SSC Service Bulletin

no. 84-342

MODELS AFFECTED: MCCU15RA, MCBU19A PA BOARD 504-165, REV. G AND FOLLOWING

PROBLEM: POWER AMPLIFIER IS NOT STABLE

Main Board Parts Placement

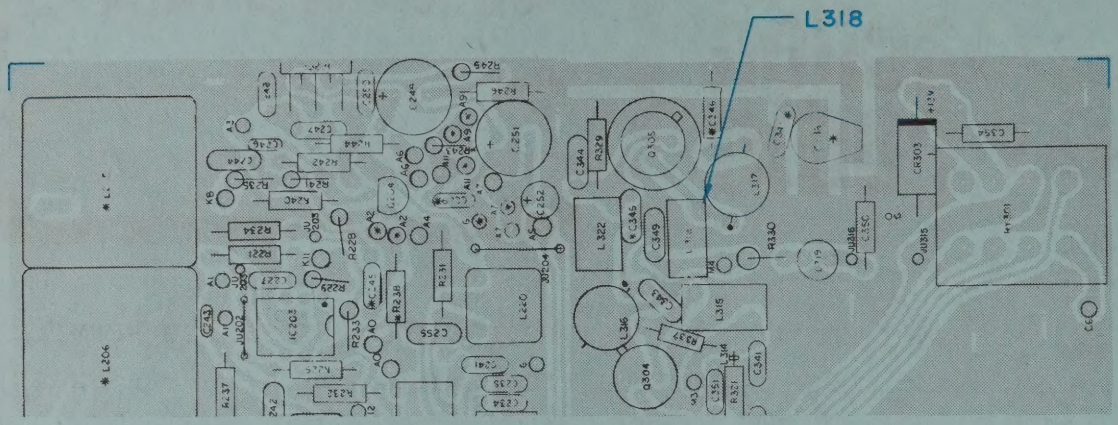
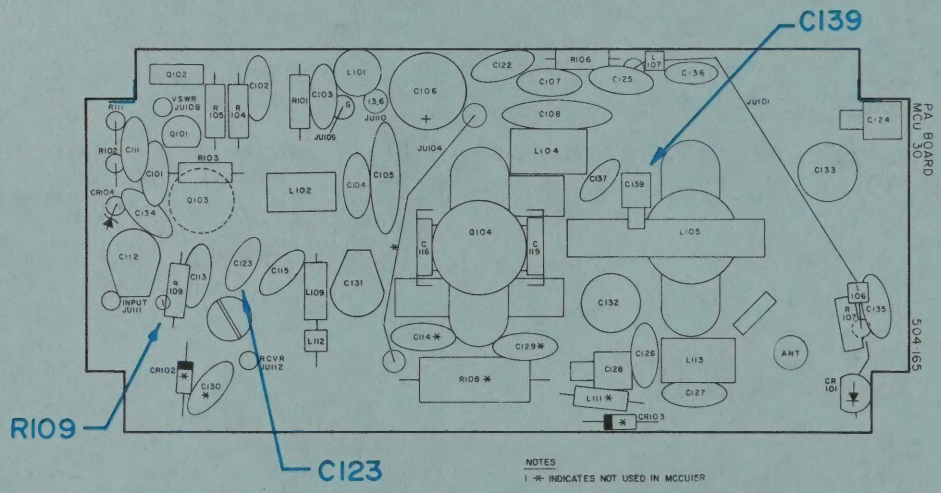
4. MCCU15RA change only.

Change L318 on Main Board to 1803-5125-901, 21/2T, LM-2.

SCHEMATIC
MCU30 P.A.
604-095E

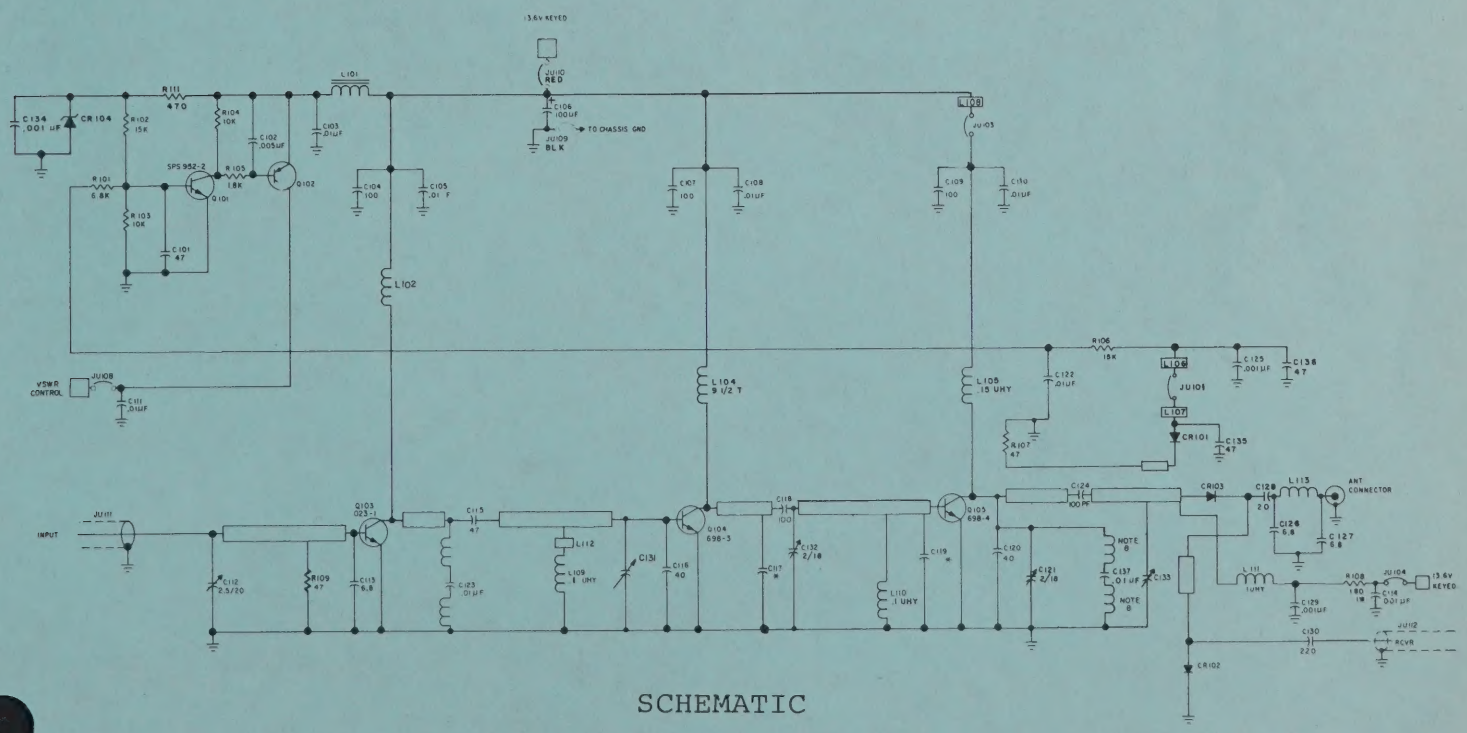
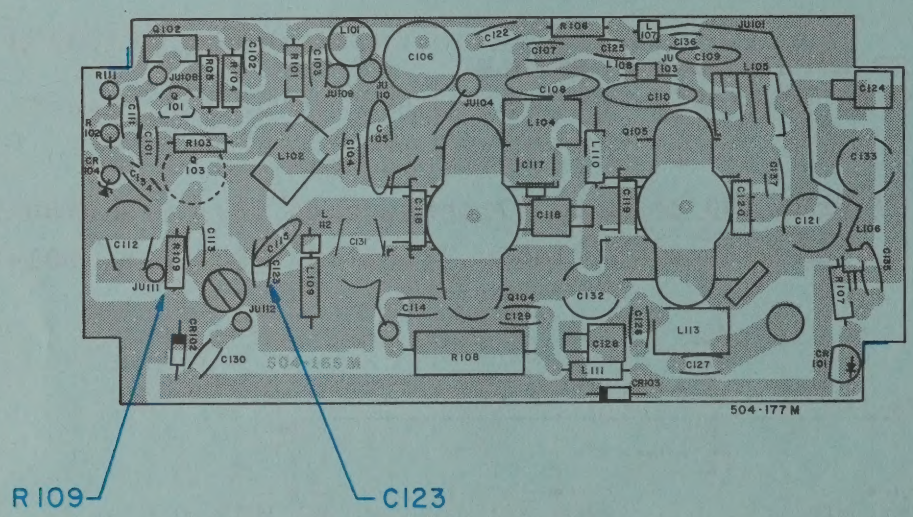
PROBLEM: POWER AMPLIFIER NOT STABLE

1. Change R109 from 100 ohms to 47 ohms, comp 10%, P/N 4700-0470-042.
2. Add C123, .01uF with 0.75" leads, Y5P, 100 VDC, P/N 1501-0103-031.
